Discuss and take appropriate action on Workman change orders for Williamson County Regional Park.

RE: Williamson County Regional Park

The following synopsis is a breakdown for Change Order #8.

## Change Order #8

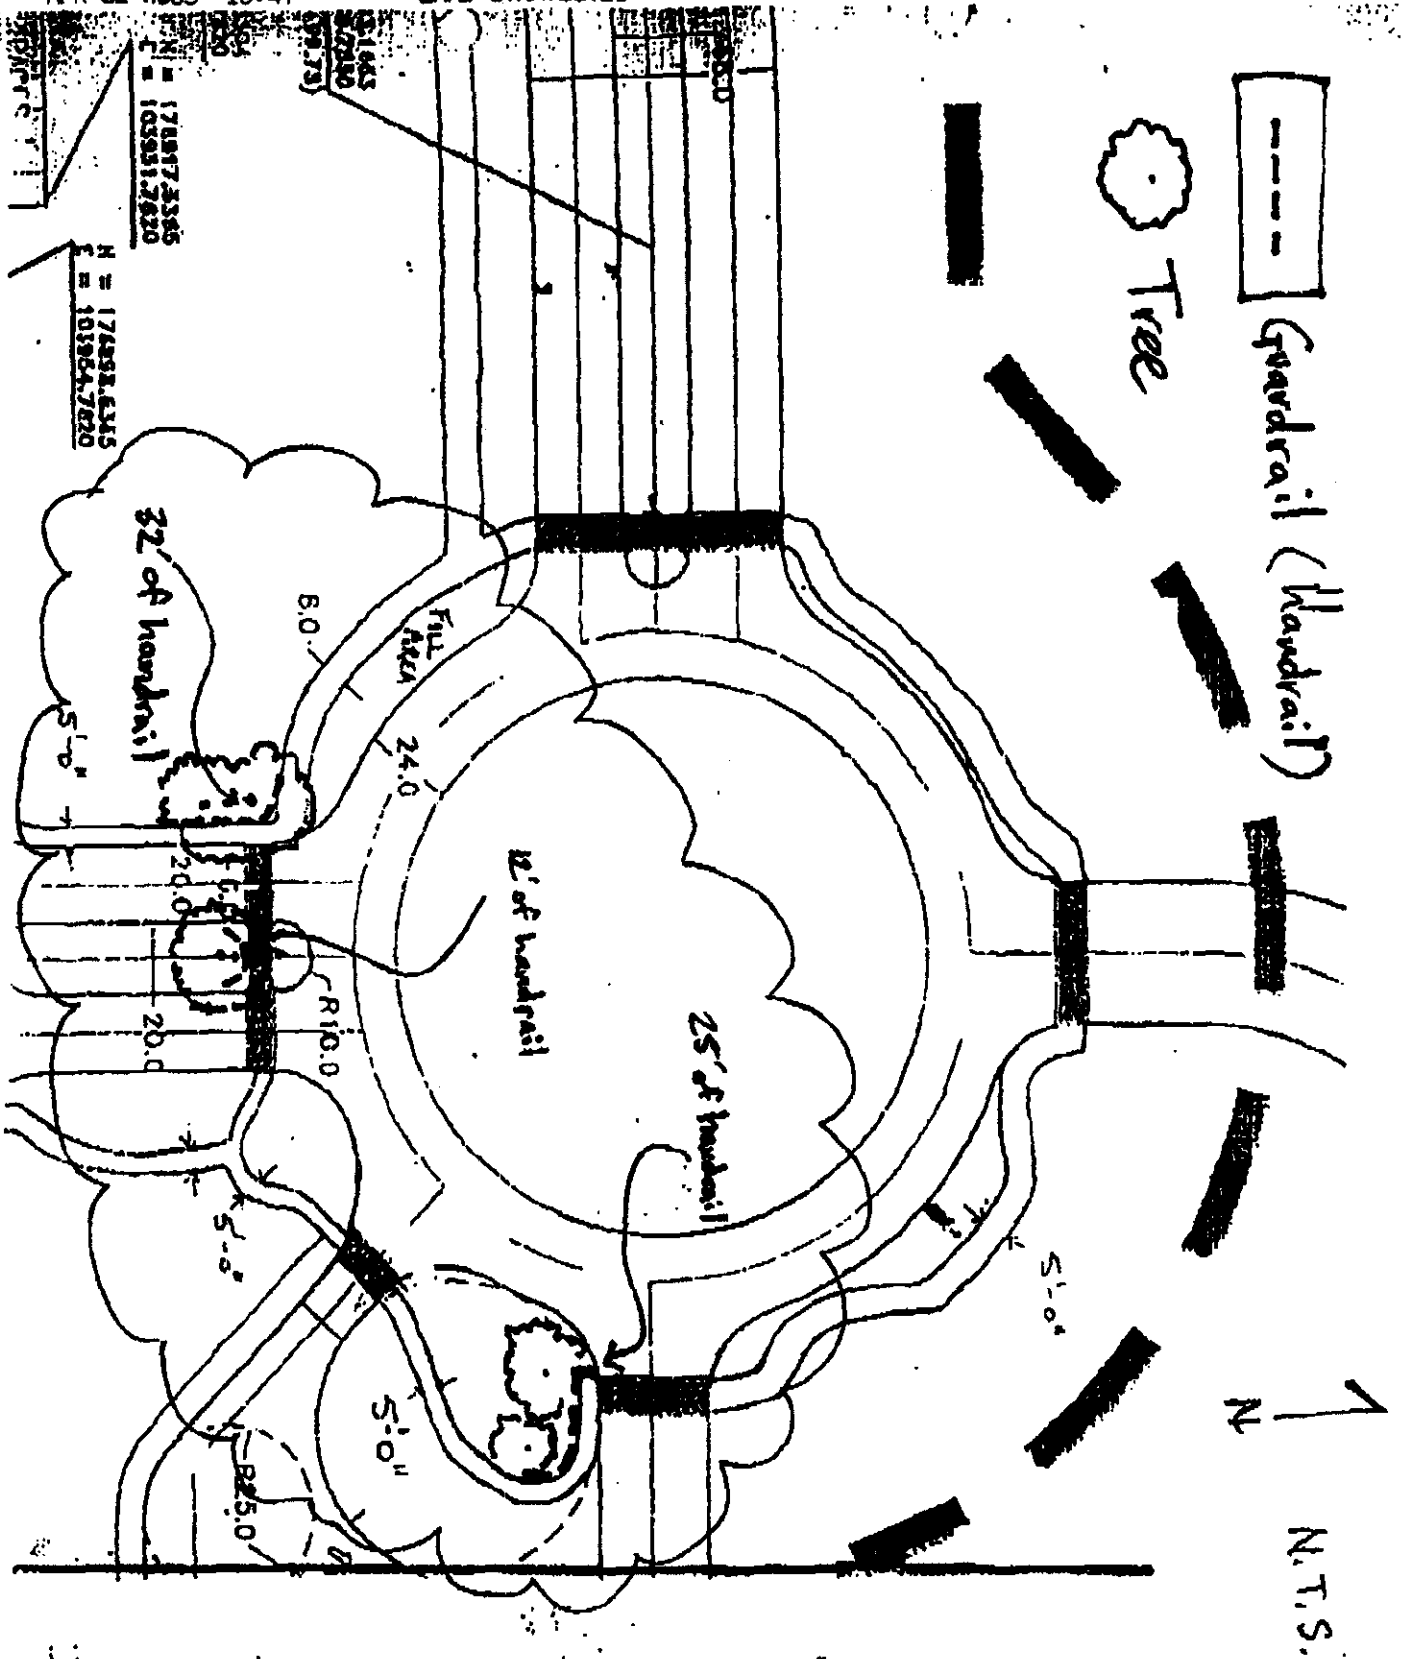
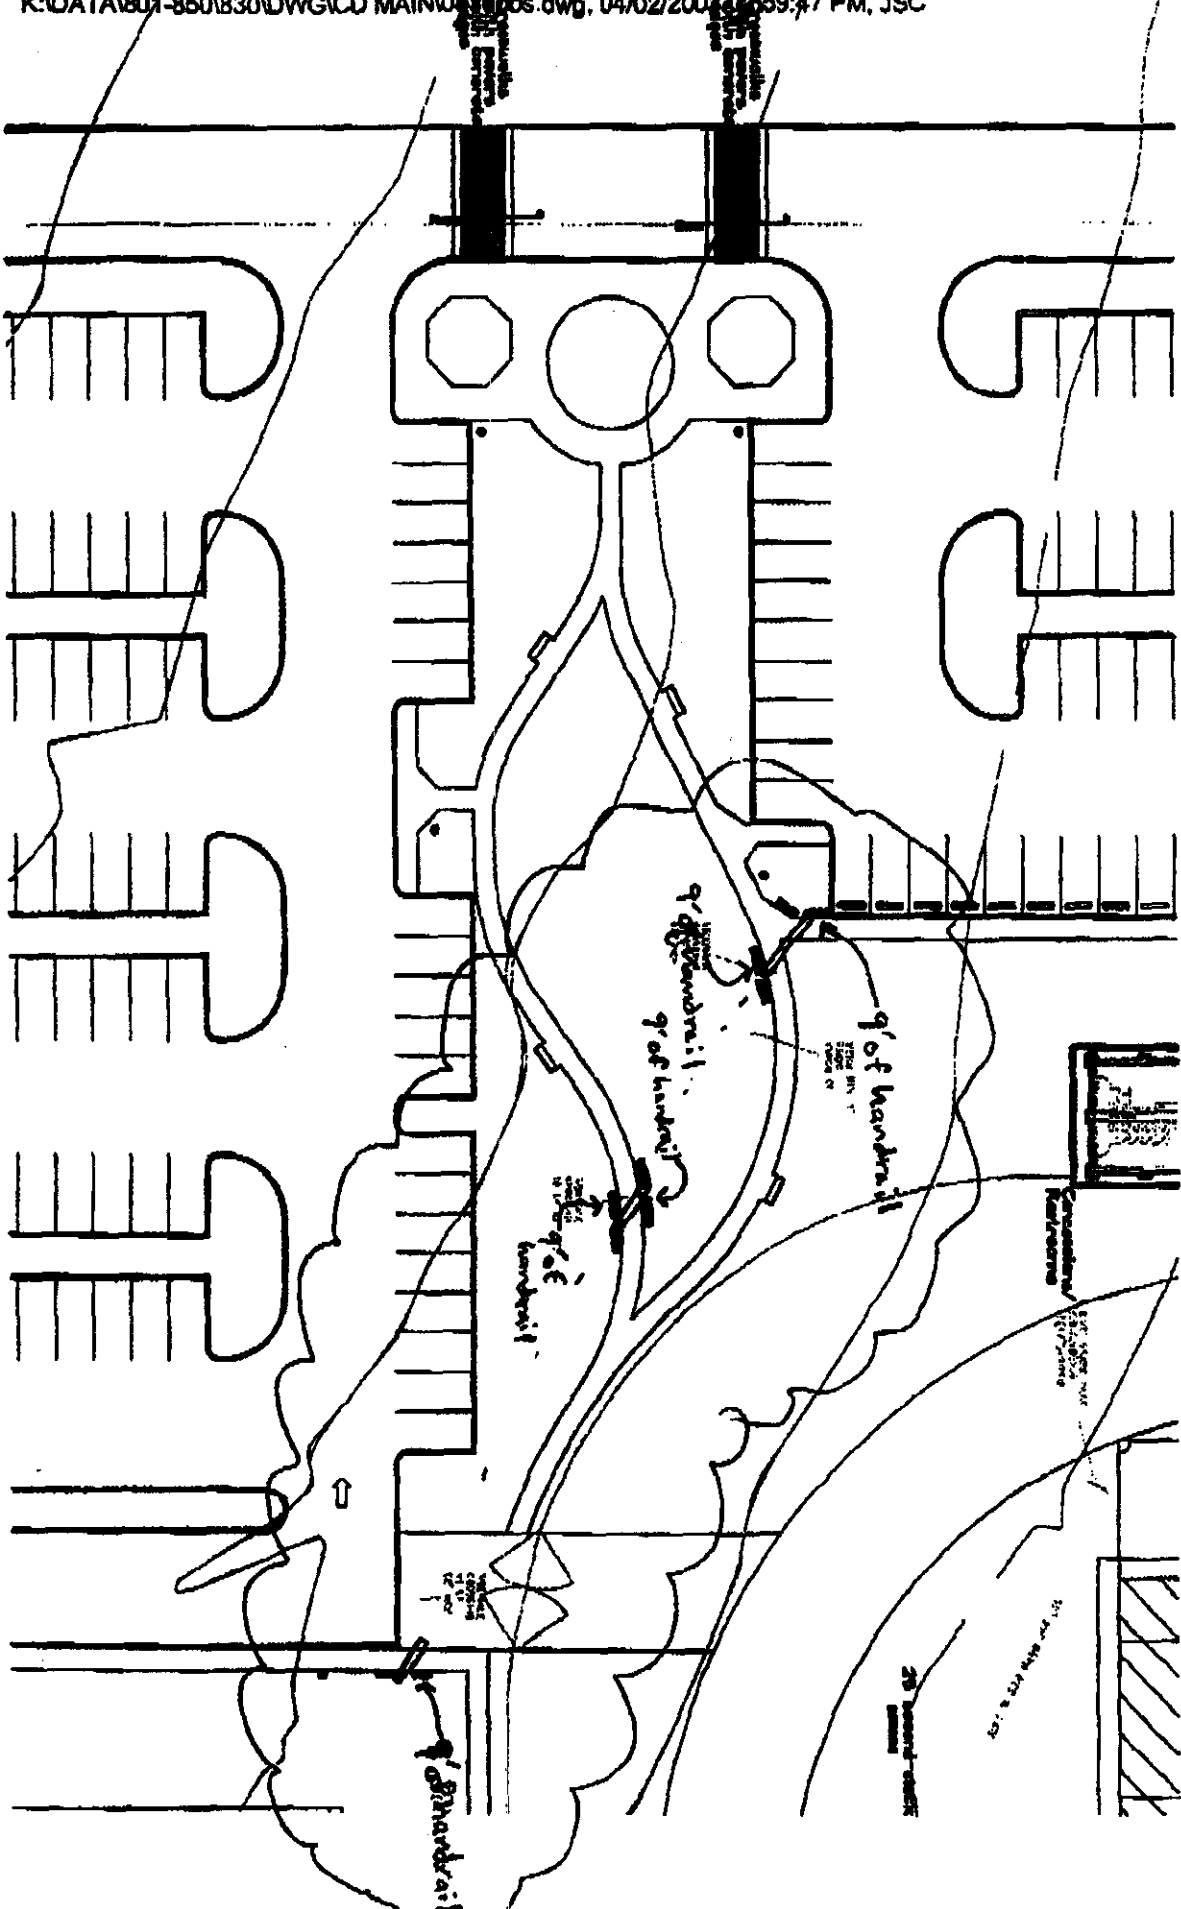
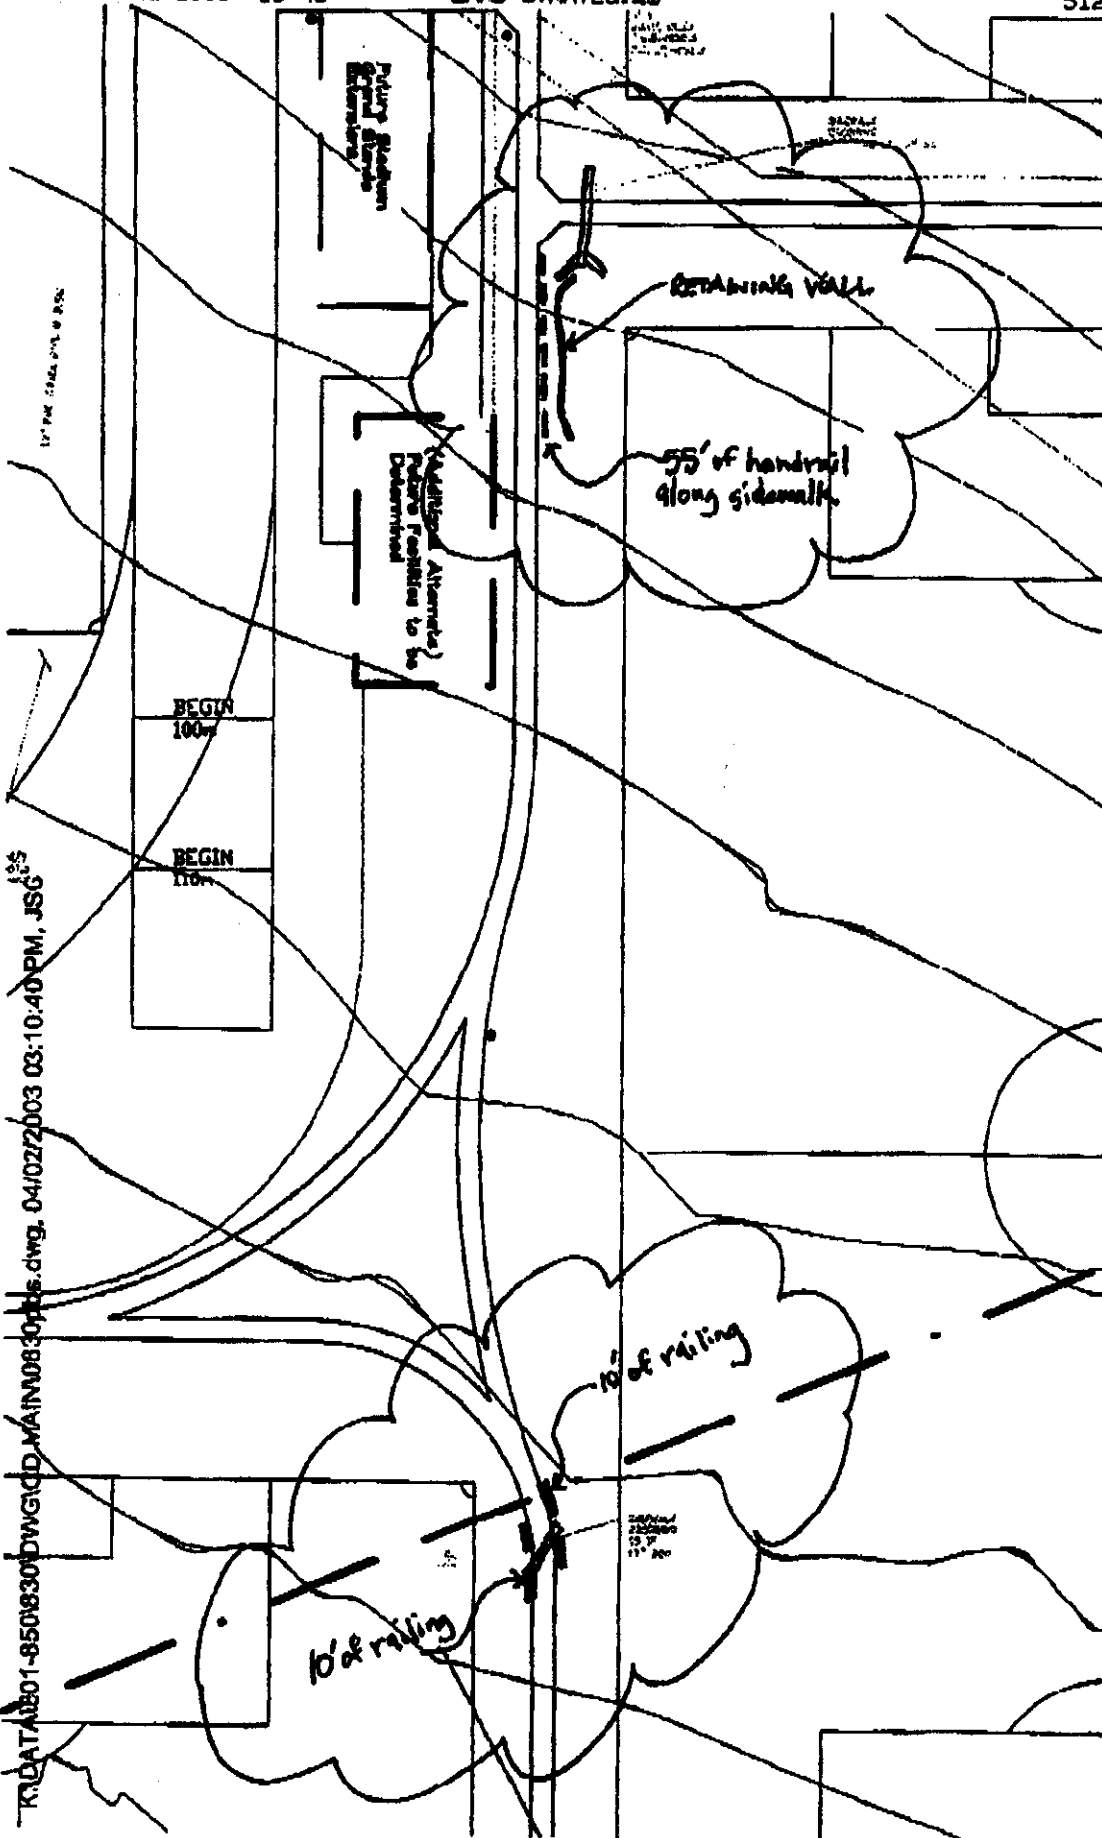
This change incorporates the additional scope of work to install handrails at various locations at the Williamson County Regional Park project. This includes: all labor, material, equipment, supervision, & incidentals required to perform this work per Land Strategies, Inc. attached sketches; all core drilling in concrete; all field measurements and welding; all painting of handrail to be green to match entry gate; all handrail to meet TAS standards with regards to pipe diameter and terminations; and all cleanup. Land Strategies to verify placement of handrails. Workman Corporation, nor any of its subcontractor's, shall be responsible for the layout or placement of handrails. This work shall be performed based upon the documents provided by Land Strategies with regards to handrail locations. Please see attached.

-The attached sheets show locations for future Guardrail (handrails) placement and their linear footage.
